Blythe Energy Center Transmission Line Project
Request for Staff Approved Modification
(99-AFC-08T)
Response to Data Request - Revised 2/8/11

TECHNICAL AREA: Transmission System Engineering
AUTHOR: Ajoy Guha

DATA RESPONSES

BLYTHE ENERGY		JOB NUMBER	REV
BLYTHE PLANT GSU-GIS OH 230KV TRANSMISSION LINE		115210	B
PLAN AND PROFILE DRAWING		DRAWING NUMBER P1-1

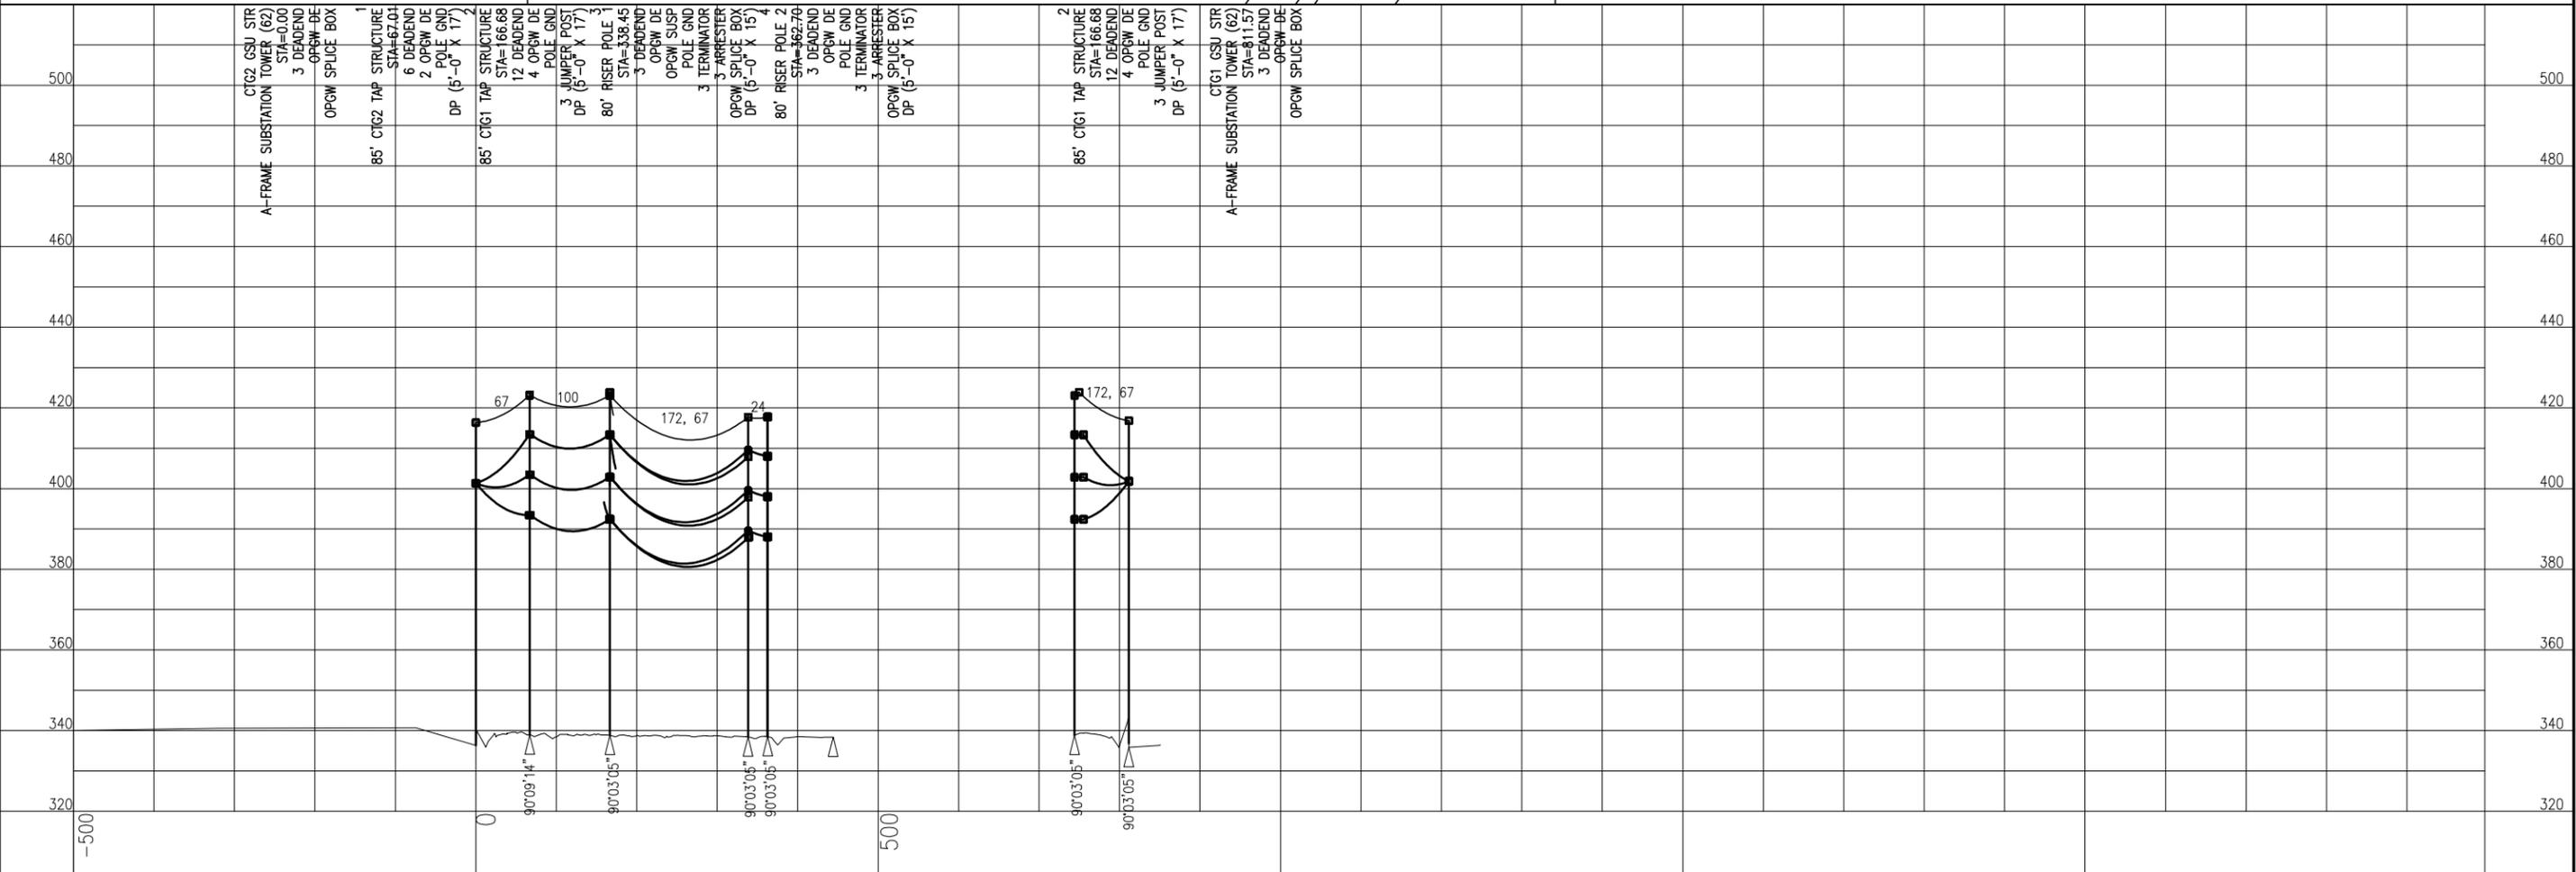
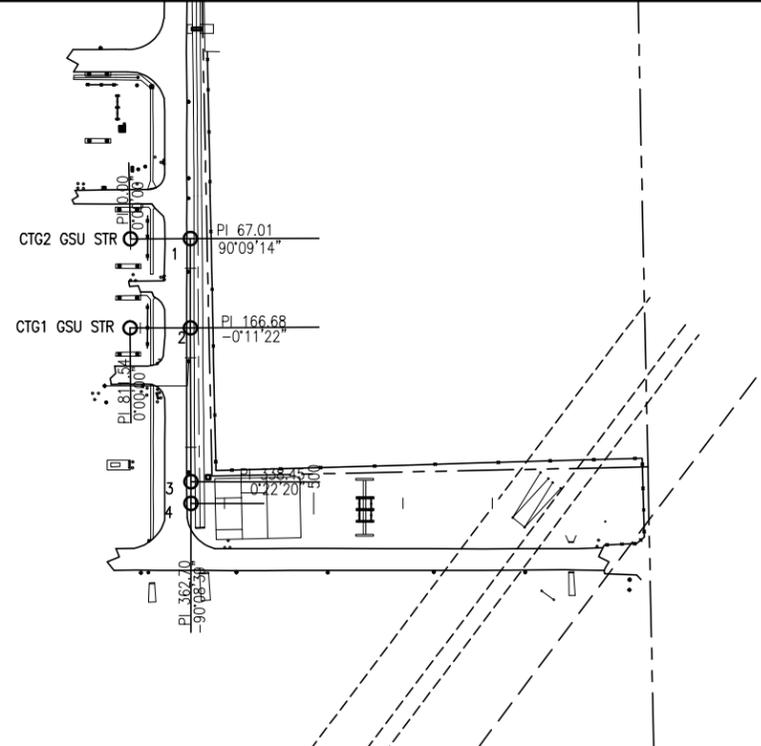
DATA REQUEST 1: Provide respective lengths of the overhead and underground portions of the tie lines and a physical layout scaled drawing (legible) showing distinctly the routes of the proposed 230 kV lines from the BEP 230 kV switchyard to the new 230 kV GIS substation and relative spacing between the lines including Right of Way (ROW) widths, if any.

DATA REQUEST 6: Provide a scaled layout diagram showing how the existing BEP 230 kV transmission line to SCE Julian Hinds substation would be re-routed and connected to the new 230 kV GIS substation. Also provide a Pole design diagram with the overhead line conductor sizes and ampere rating.

DATA RESPONSE 1: Figure 1 shows an isometric overall view of the overhead and underground portions of the line. Figure 4, sheets GO-1 and P1-1 and Figure 5, sheets P1-1 through P 1-6, are scaled drawings showing the routes of the proposed 230kV lines from each of the BEP turbines, including a future position, to the new 230kV GIS. Note that the interconnection with the substation will entirely bypass the existing Western (WAPA) substation. The interconnection between the turbines and the GIS will all be located entirely within the BEP property. No additional ROW will be needed.

DATA RESPONSE 6: Please see Figure 2, showing the scaled arrangement of the GIS, Figure 4, sheet P1-1, and Figure 5, Sheet P1-6.)Overhead conductor being used for the generator to GIS tap is 1033.5 kcmil ACSR 'Curlew' with an ampacity rating of 1047 amps. The Blythe to Julian Hinds line conductor is triple bundled 1033.5kcmil ACSR 'Curlew' with an ampacity rating of 2008 amps.

BLYTHE ENERGY, LLC		JOB NUMBER	REV
BLYTHE ENERGY CENTER GSU-GIS OH 230KV TRANSMISSION LINE		115210	△
CTG2 TAP STRUCTURE		DRAWING NUMBER	
		S1-1

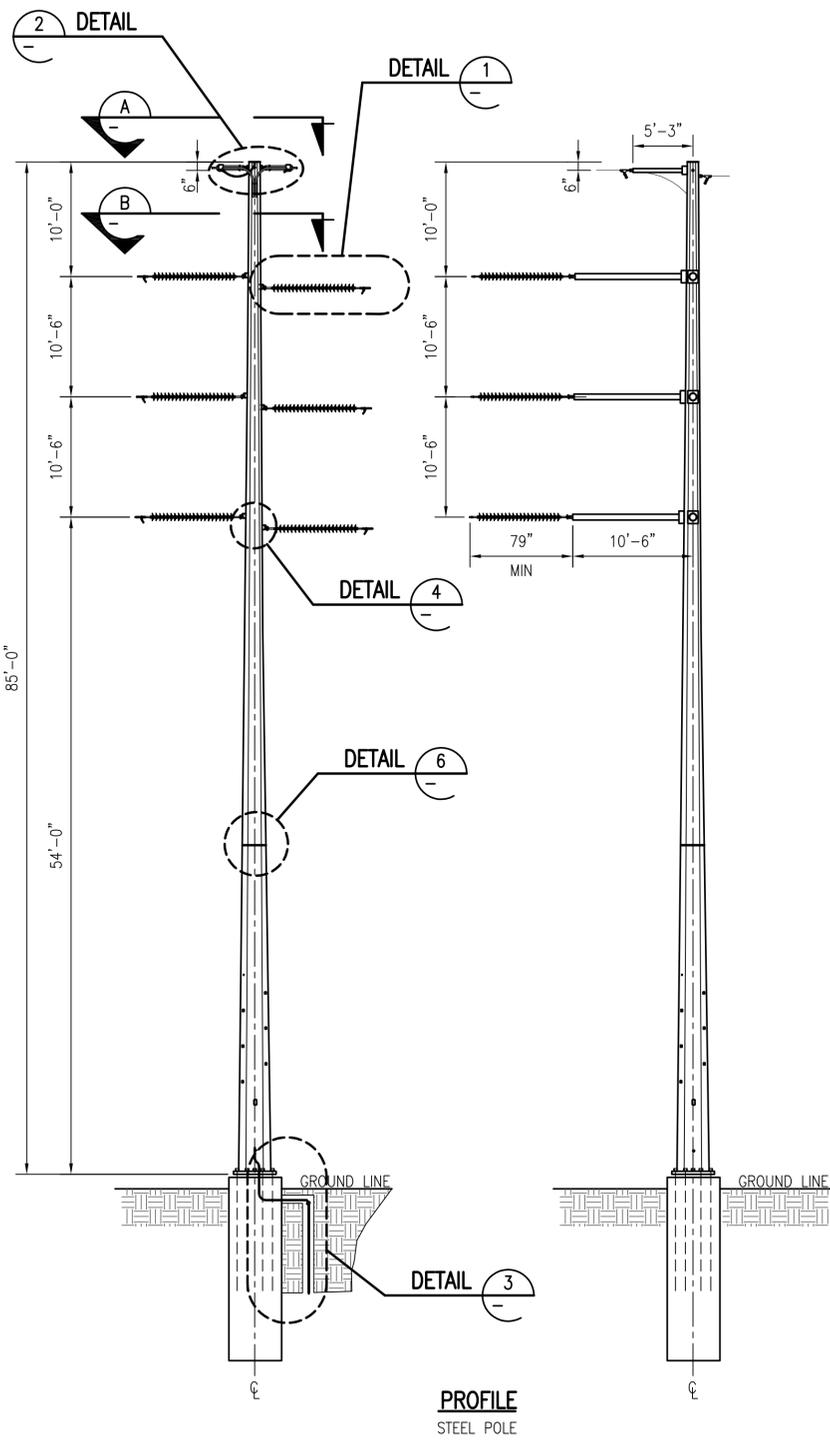
DATA REQUEST 2: Submit Pole design diagrams for intermediate and dead-end structures of the generator overhead 230 kV tie lines showing configuration of insulators and conductors with their respective position measurements on the pole. Provide the sizes, types and ampere rating of the overhead line conductors.

DATA RESPONSE 2: Please see Figure 4, sheet L1-1 and sheets S1-1 through S1-4A for requested design diagrams. The overhead conductor being used for the generator to GIS tap is: 1033.5 kcmil ACSR 'Curlew' with an ampacity rating of 1047 amps.

Structure drawings in Figure 4, S1-1 through S1-4 have been updated to confirm phase-ground clearance and the transition from Overhead to Underground. The total height of the pole above ground and the ground clearance from the lowest phase conductor has also been added to these drawings.

JOB NUMBER	REV
115210	B
DRAWING NUMBER	
S1-6

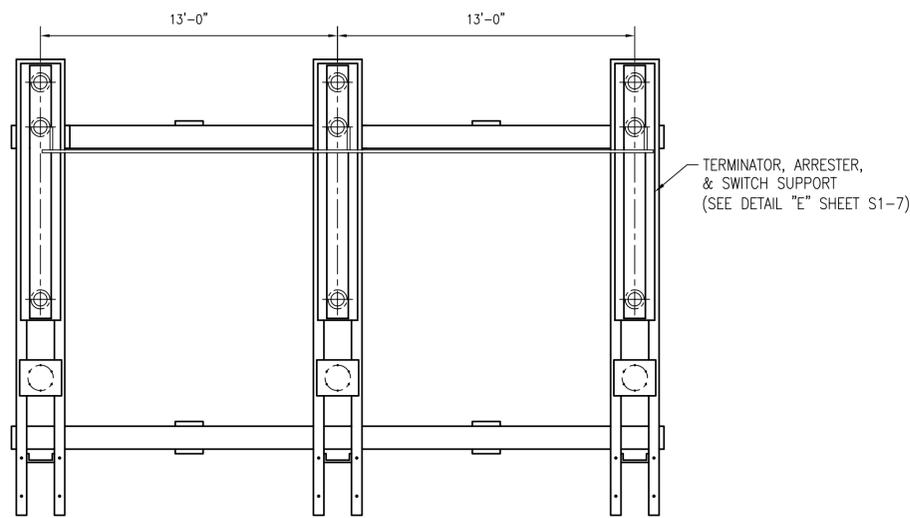
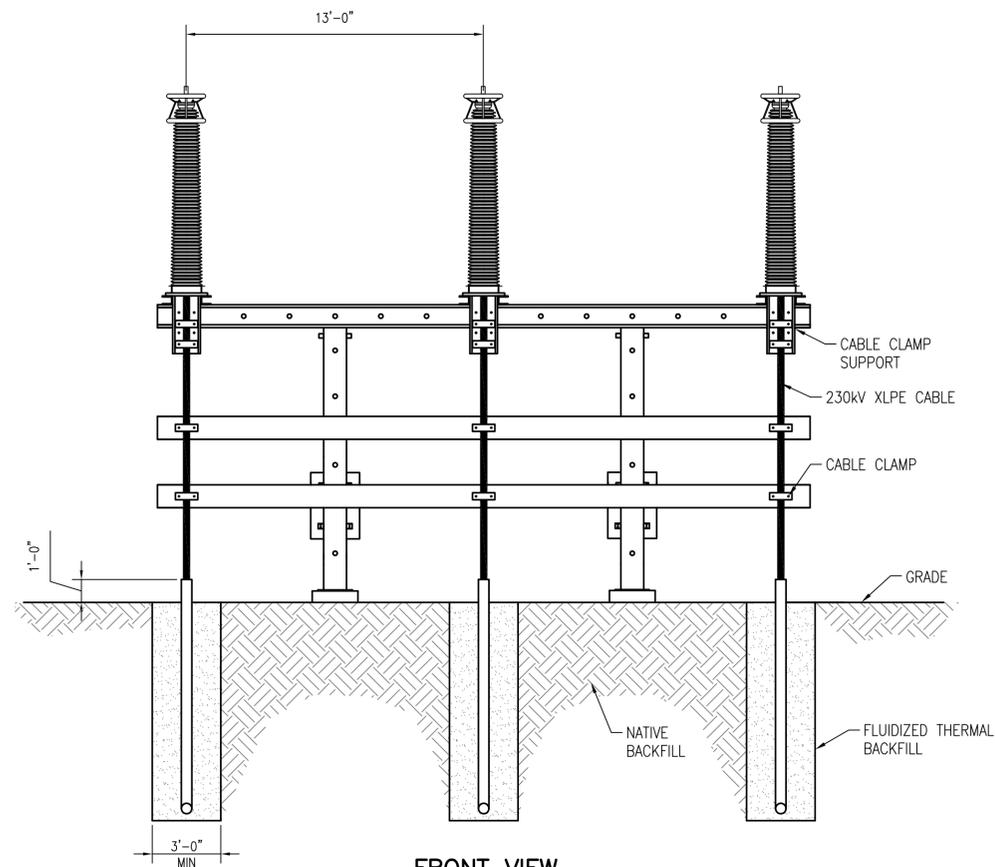
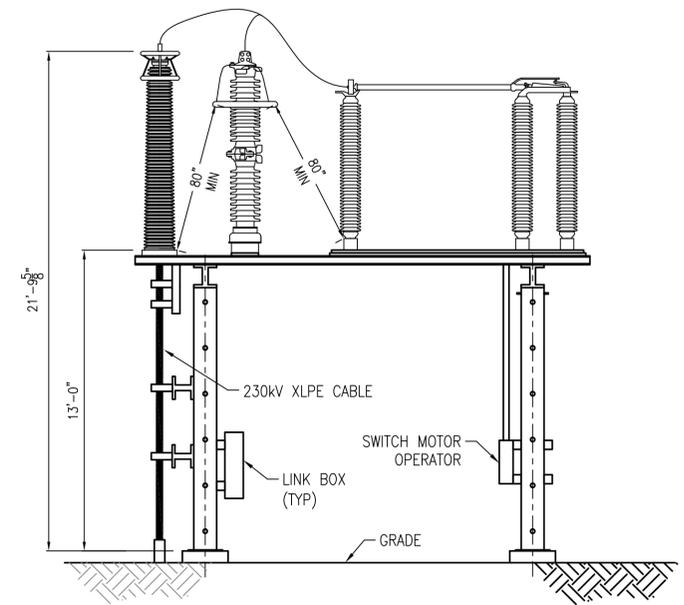
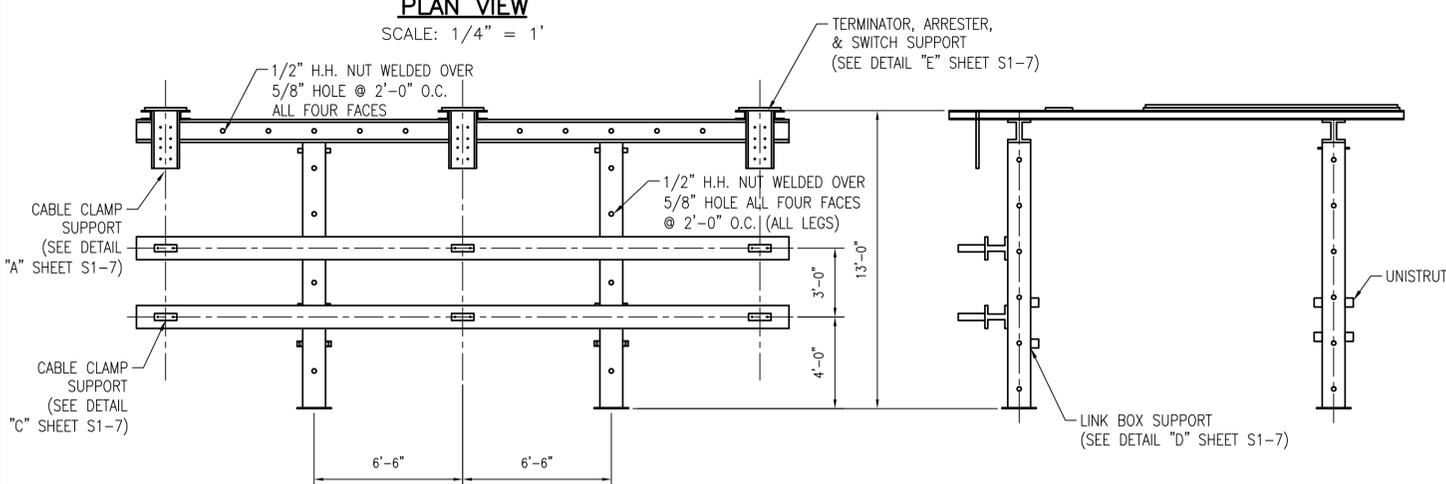
DATA REQUEST 3: Submit a design diagram showing termination of an underground 230 kV cable line to an overhead 230 kV line with respective measurements on an H-frame (or any other) structure for all three phases.

DATA RESPONSE 3: Please see Figure 3 and Figure 4, Sheets S1-5 and S1-6 for requested design diagrams, showing respective measurements for all three phases.

Figure 4, S1-6 has been updated to more clearly identify Underground cable on the front view and side view.
